PRODUCT ADVISORY

Data Sheet Specification Change for Intersil Product ISL36111*

**Refer to:
PA10105**

Date: October 27, 2010

FIGURE 8. TYPICAL APPLICATION REFERENCE SCHEMATIC FOR ISL36111

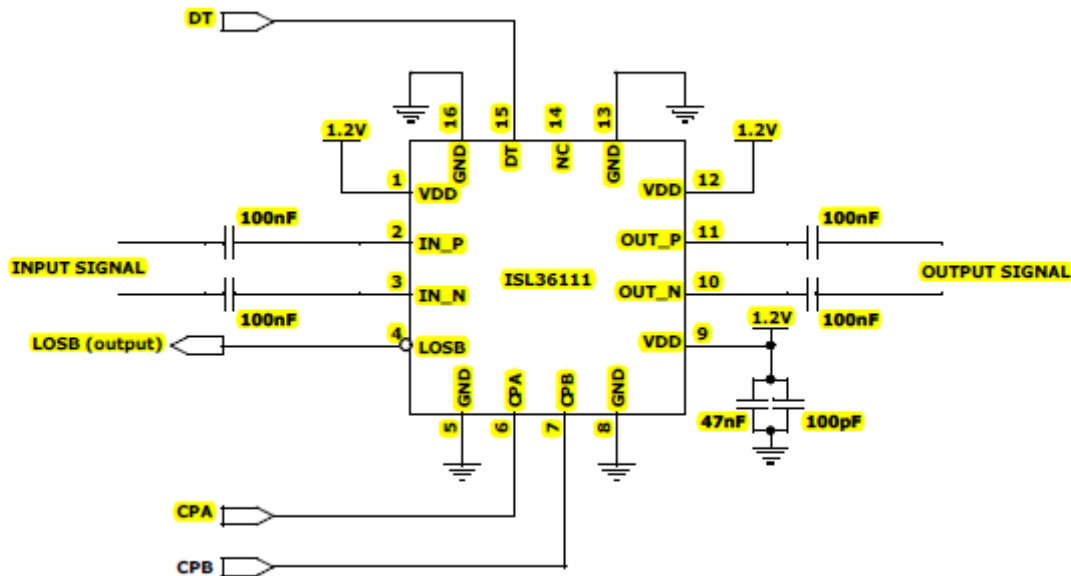
- i) The description for the VDD pin in the Pin Descriptions table was updated to recommend the use of parallel 100pF and $47nF$ decoupling capacitors to ground for each of these pins.
- ii) The description for the CP[A,B] pin in the Pin Descriptions table was updated to indicate the pins are read as a *2-digit* number to set the boost level.
- iii) Added Figure 8 - Typical Application Reference Schematic and a section titled PCB Layout Considerations.

Typical application schematic for ISL36111 is shown in Figure 8.

- 14. See "Control Pin Boost Setting" on page 5 for information on how to connect the CP pins
- 15. See "Detection Threshold (DT) Pin Functionality" on page 6 for details on DT pin operation.
- 16. Although the filtering network is shown only for one V_{DD} pin for simplicity, all the V_{DD} pins need to be connected in this way.
